DANE COUNTY DEPARTMENT of PUBLIC WORKS, HIGHWAY and TRANSPORTATION

RFB NO. 313083 - ADDENDUM NO. 3

CONSTRUCTION OF EAST HIGHWAY GARAGE – SALT STORAGE FACILITY (BID PACKAGE A) AND MEDICAL EXAMINER OFFICE BUILDING (BID PACKAGE B)

**DEPARTMENT OF PUBLIC WORKS,
HIGHWAY & TRANSPORTATION
3562 COUNTY HIGHWAY AB
MCFARLAND, WISCONSIN**

5 WINDOW LEVEL FRAMING (HIGH)
SCALE: 1/4" = 1'-0"

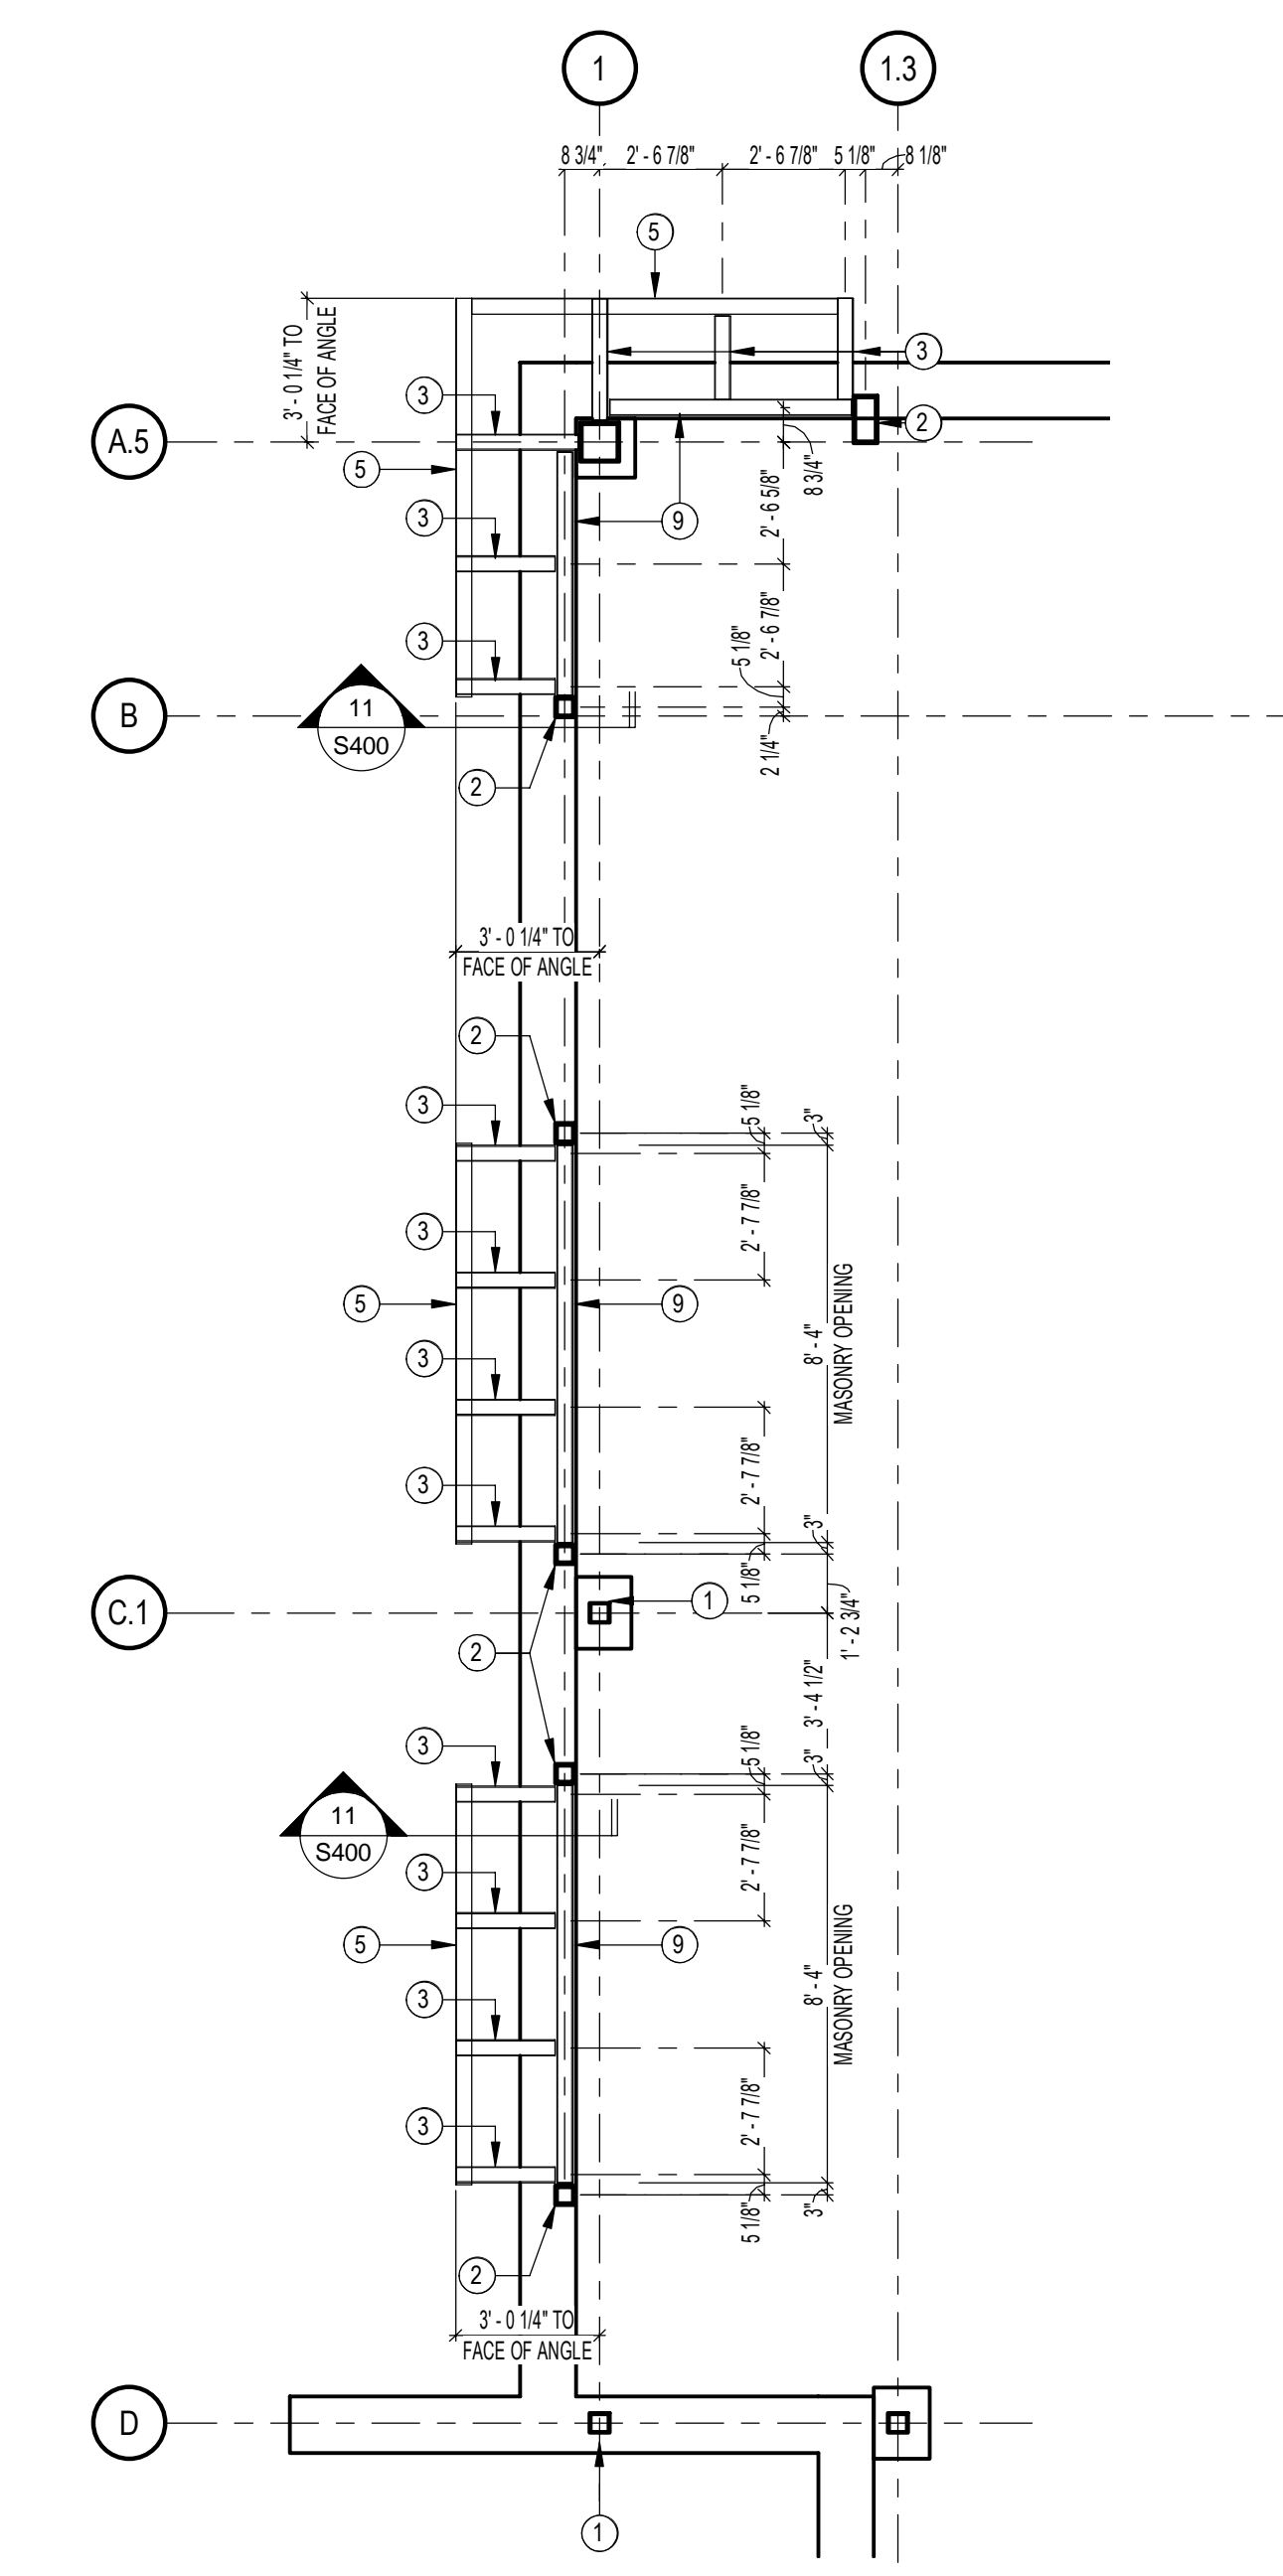
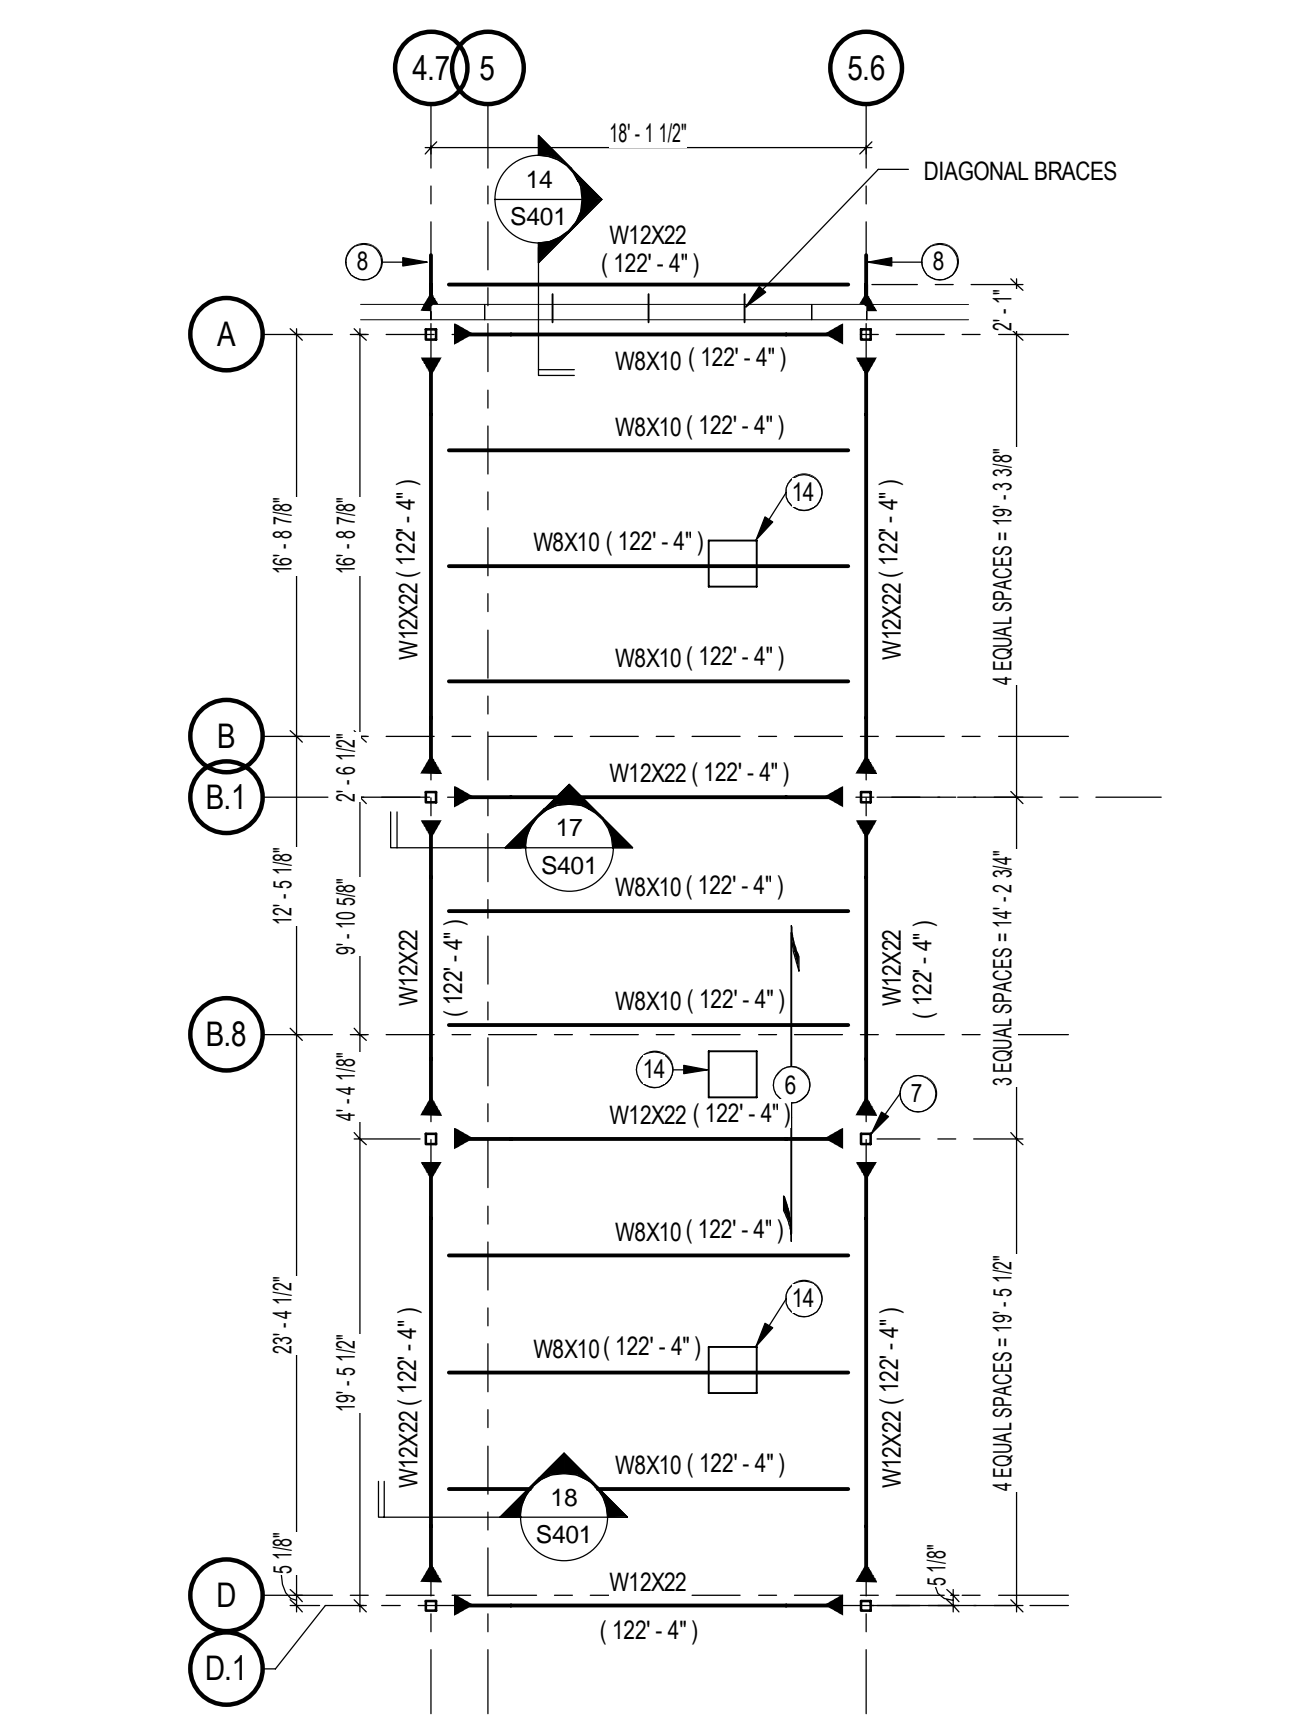
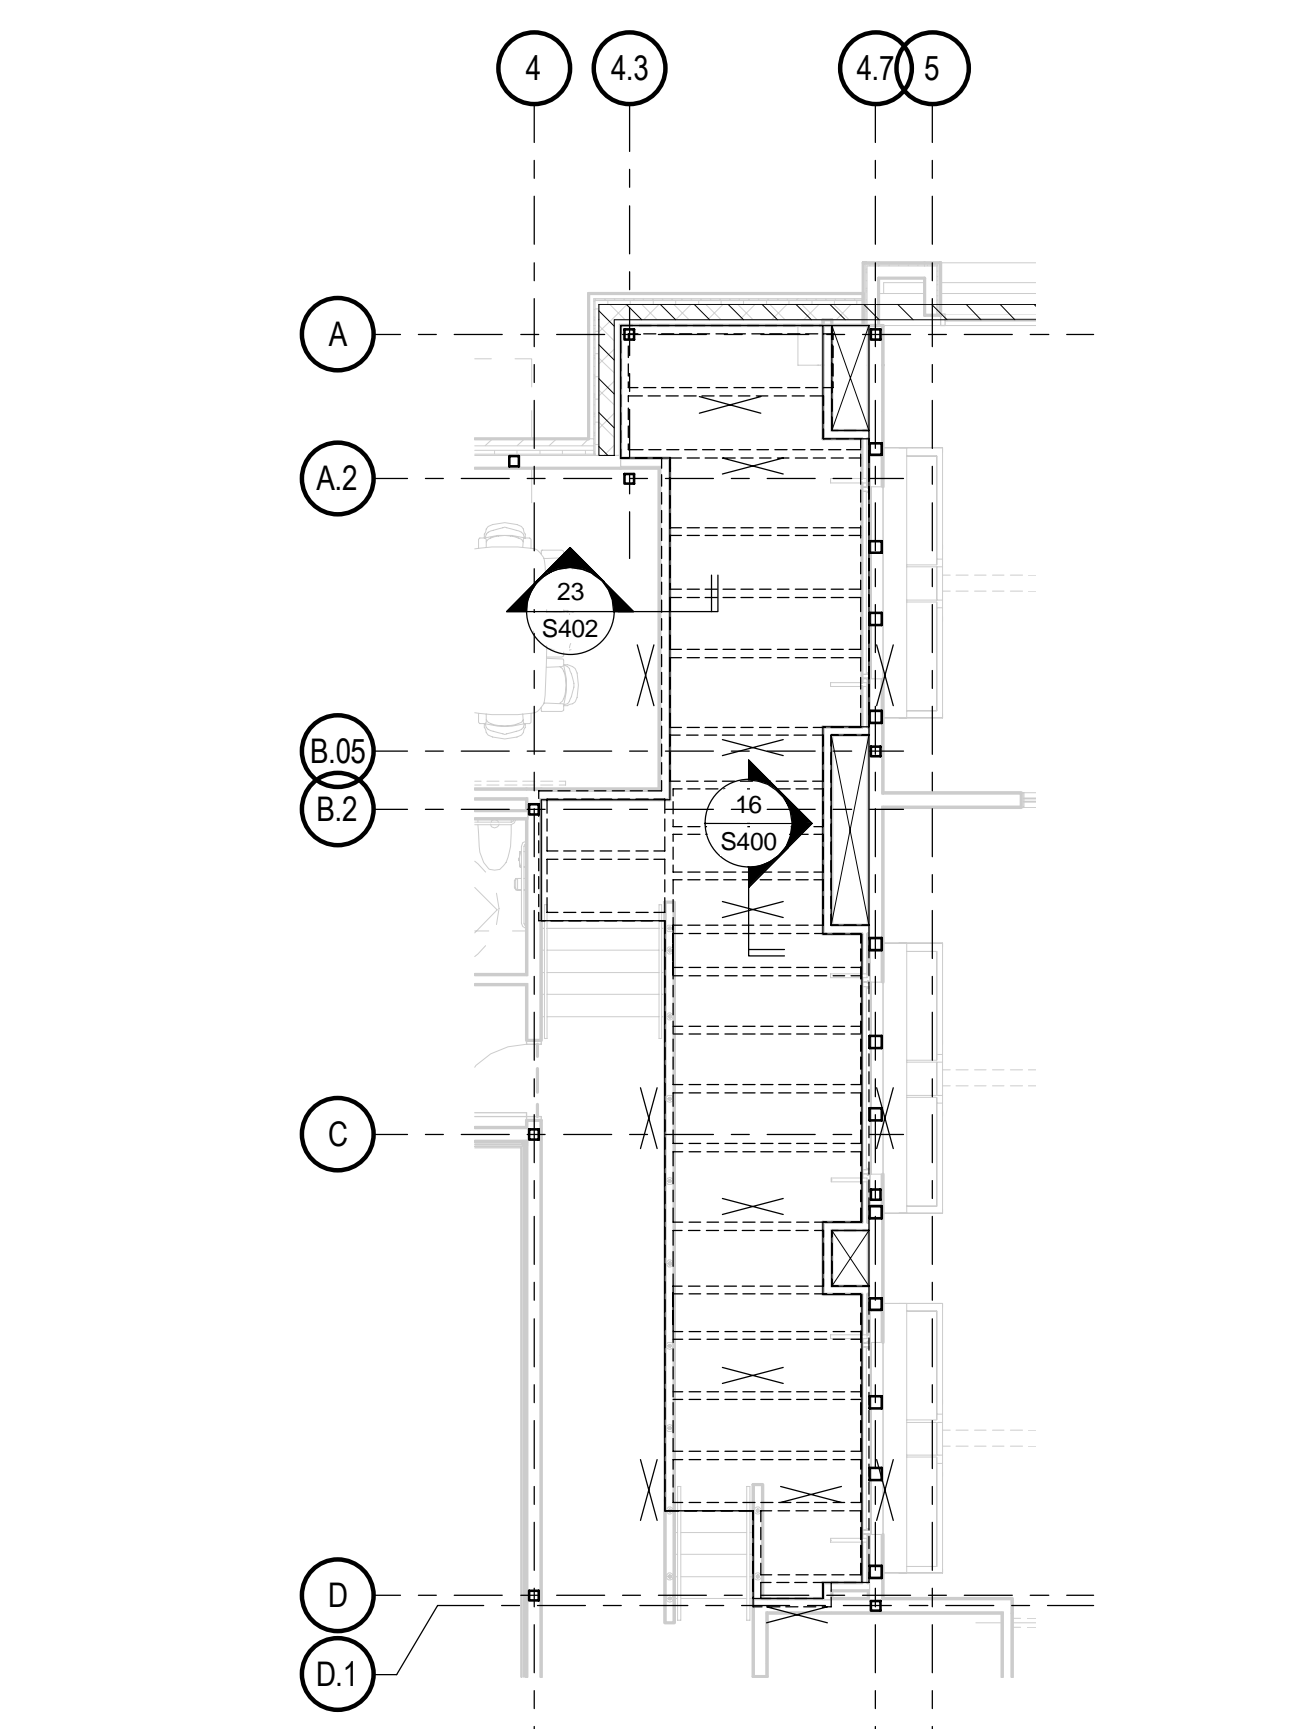
22. SHEET S200:
 - a. Replace in its entirety.
 - b. Detail 1/S200.
 - i. Revised joist size in the area of grids D.1/E and 5.6/6 to eliminate the "special" joists.

- ii. Added a note for the weight of EF-3 in the garage area.
 - iii. Added general note 4 relative to the use of AESS.
 - c. Detail 2/S200.
 - i. Eliminated the detail.

4. QUESTION/COMMENT
- a. Plan sheet S200 - Please provided the weight of the EF-3 unit along column line 11 of the Garage?
- AE RESPONSE
- a. Refer to addendum.

- a. No, bid as per Contract Documents. The submitted product information did not meet all the specification requirements.
12. QUESTION/COMMENT
- a. Question on sheet S200 the load diagram for joist 22KSP1.

- AE RESPONSE
- a. Refer to addendum.
13. QUESTION/COMMENT
- a. Question on sheet S200 and the application of detail 2/S200.
- AE RESPONSE
- a. Refer to addendum.
